Medina County Sanitary Engineers
C.H. 42 Grafton Road Water Main Replacement Project 2022
WR-500/5-1.3

ADDENDUM 2

November 1, 2022

CONCRETE BLOCKING FOR HORIZONTAL BENDS

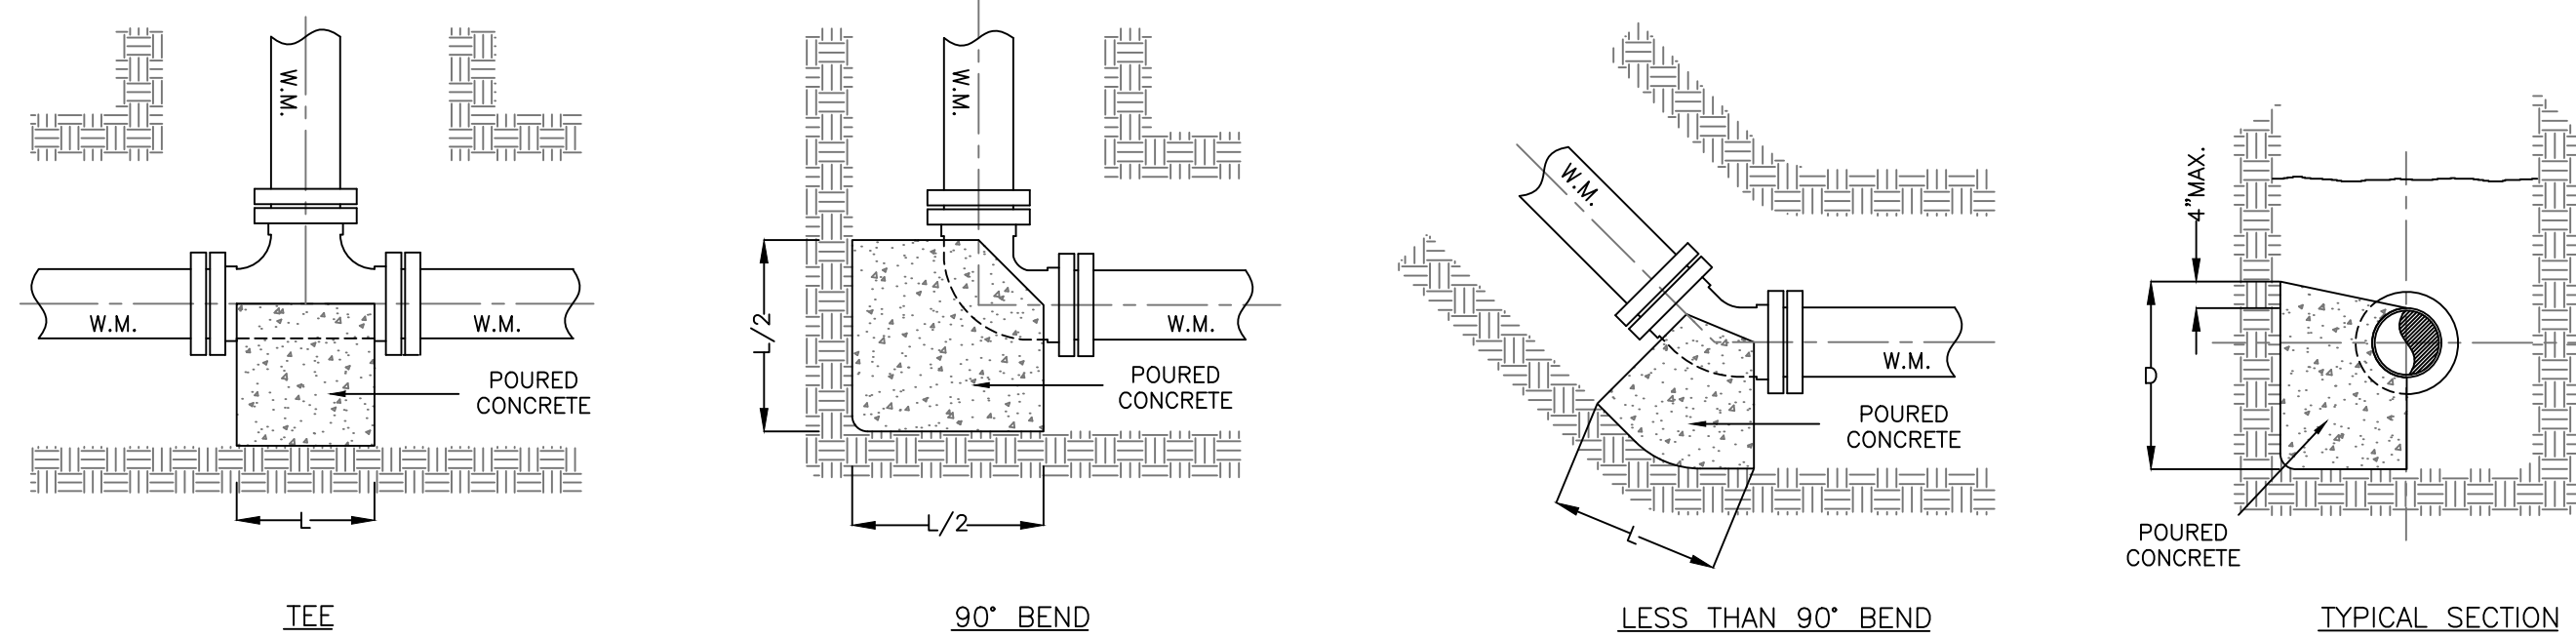
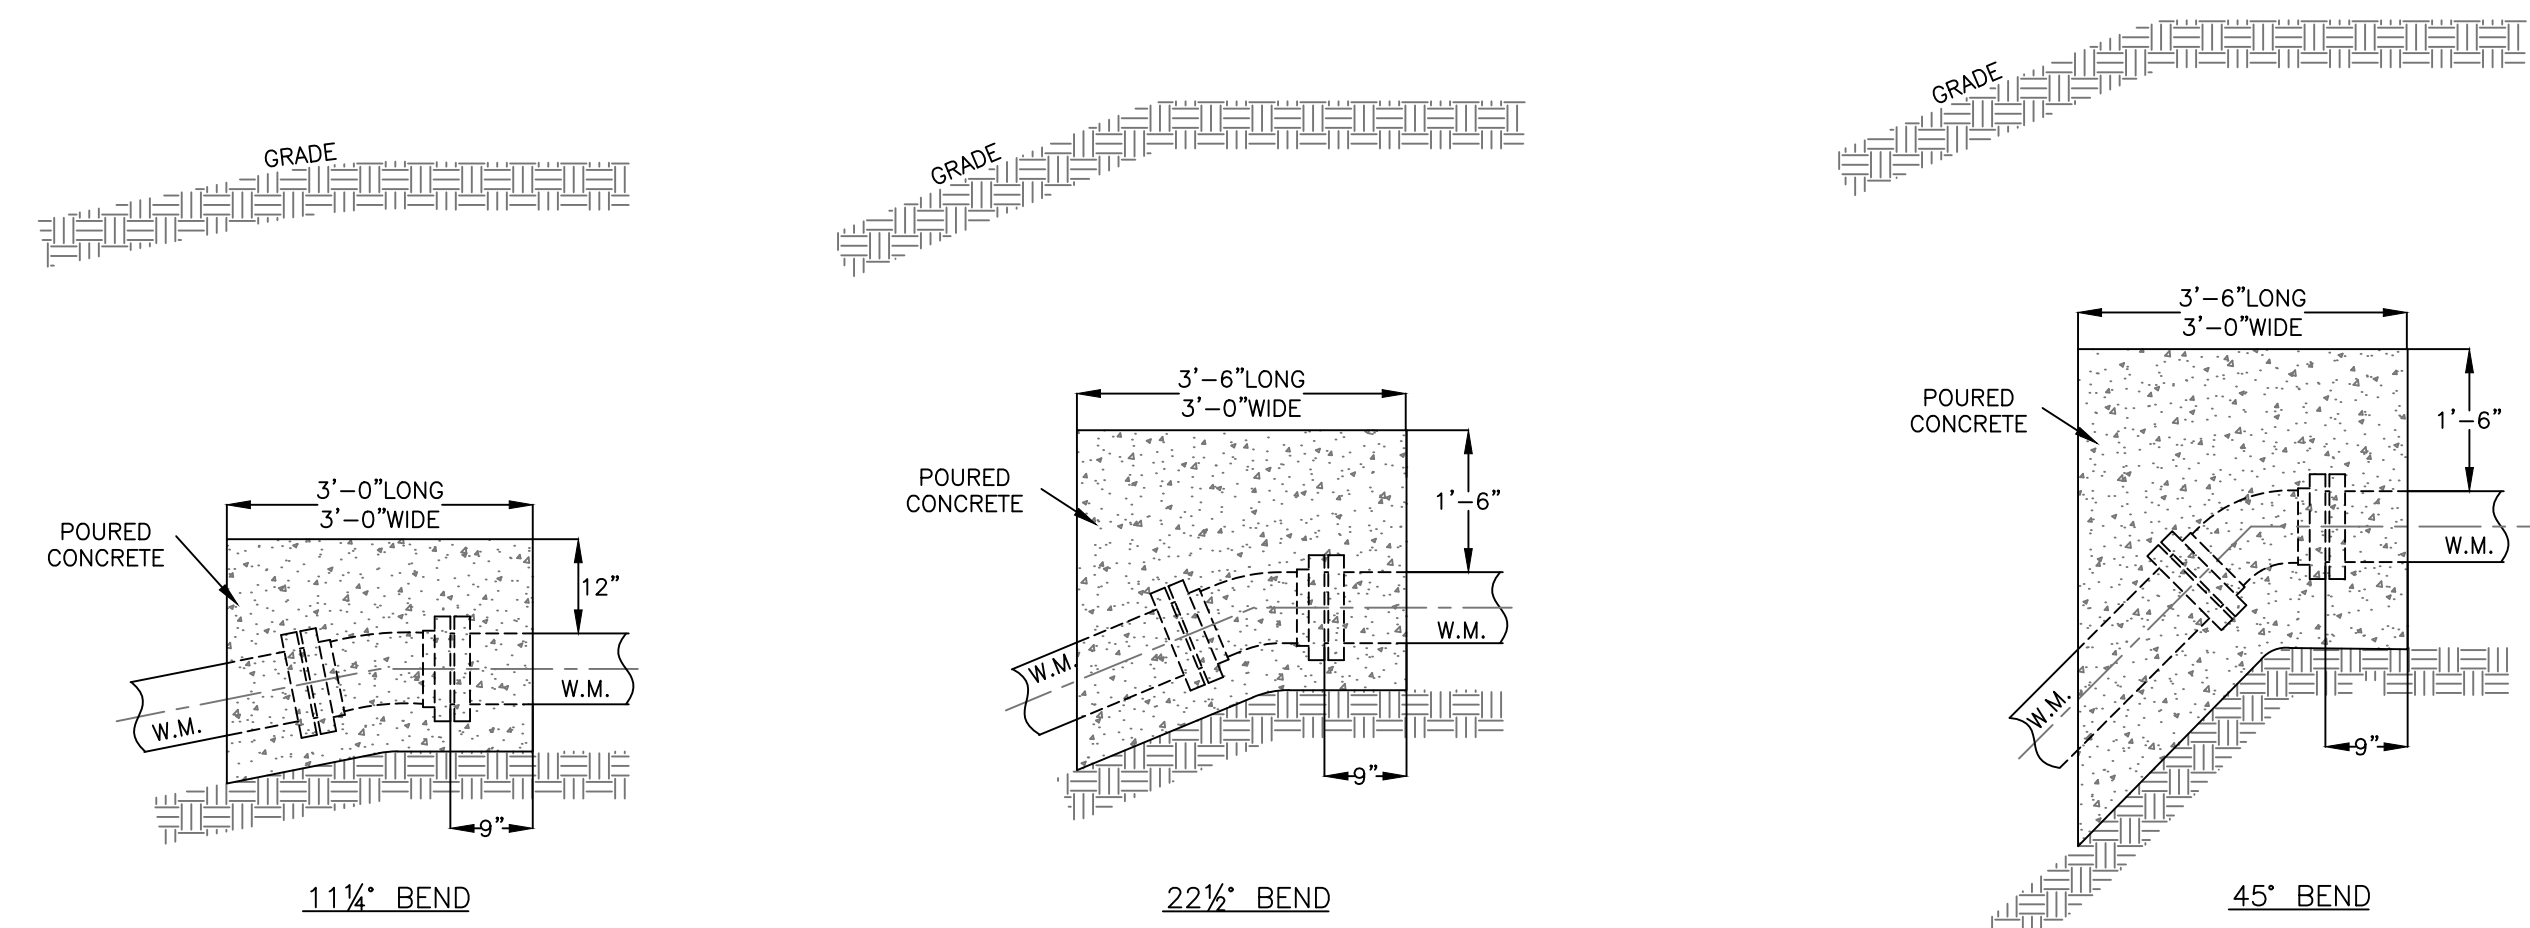
Question #11 – Can joint restraints be used in lieu of concrete thrust blocks?

No, MCSE requires concrete blocking for all horizontal and vertical bends even though the joints are restrained.

TYPICAL TRENCH SECTION

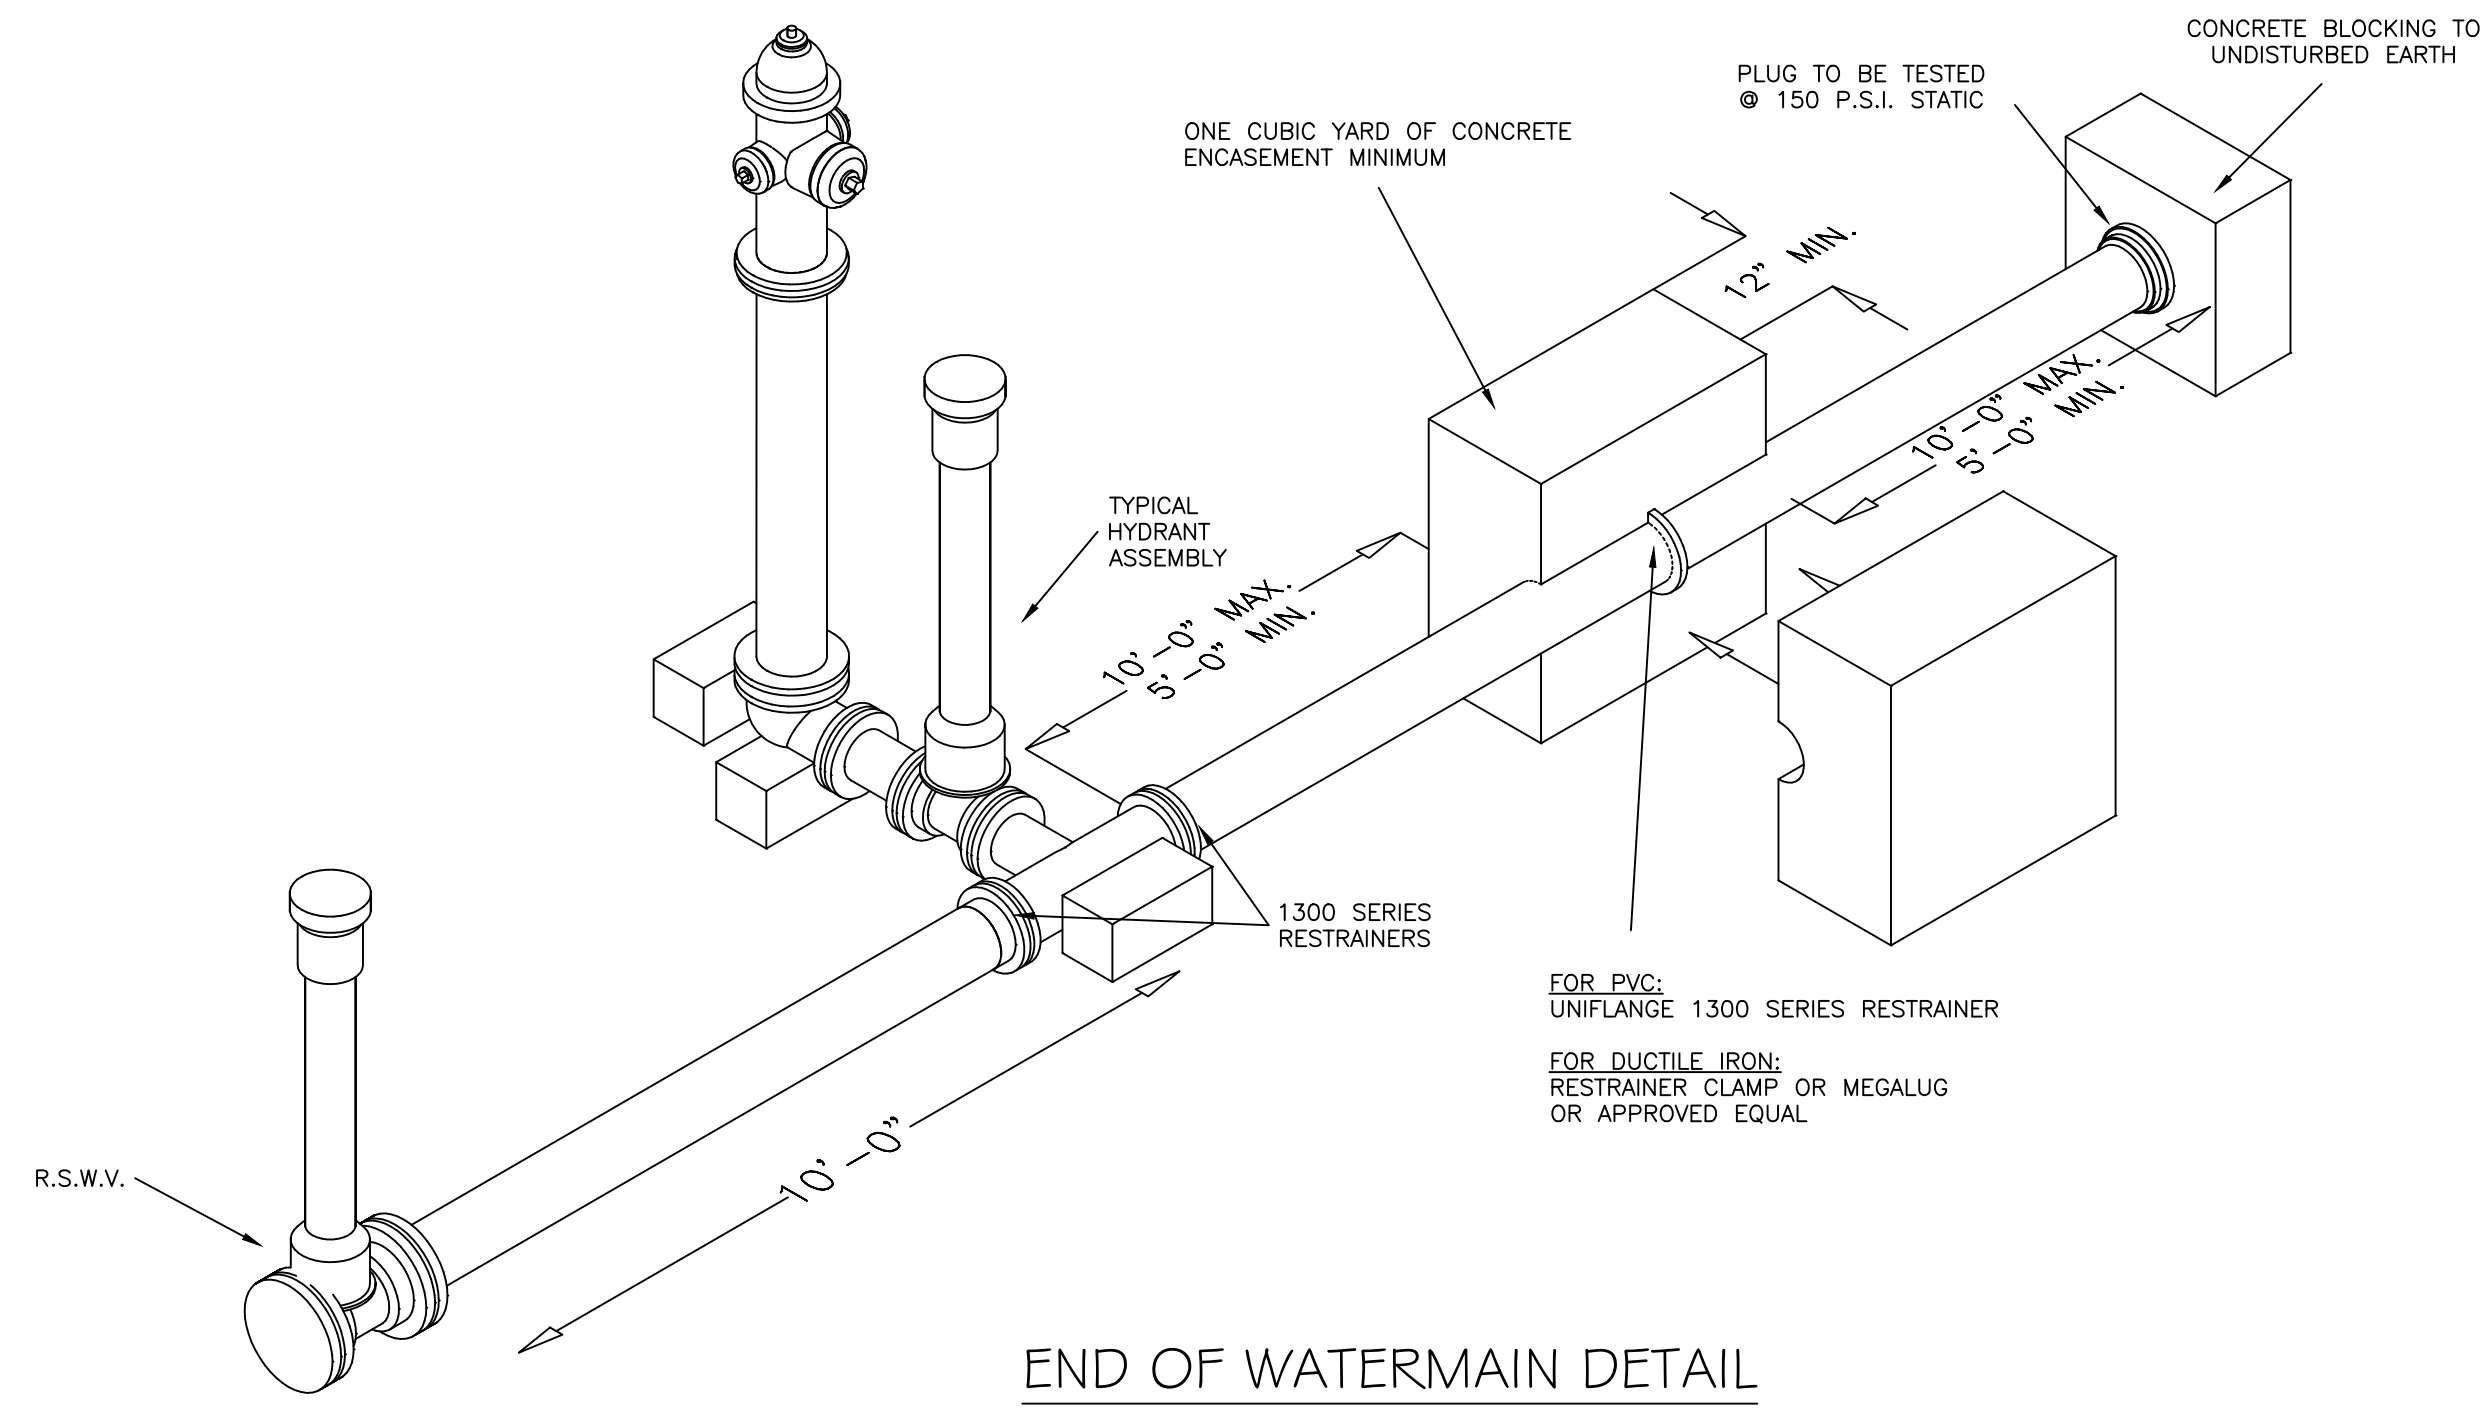
Replace Sheet 17 Water Main Standards with the attached Sheet 17 Water Main Standards.

DRAWN BY:	REVIEWED BY:	DATE: 10/31/2022	COUNTY: MEDINA
02/2021	03/2022	10/2022	
SALES: HORIZONTAL N/A / VERTICAL N/A		REVISED DETAIL SHEETS	
UPDATE OF LANGUAGE FOR CARRIER PIPE SPACING		UPDATE TO TYPICAL TRENCH SECTION	
			BY:
			DESCRIPTION
			DATE
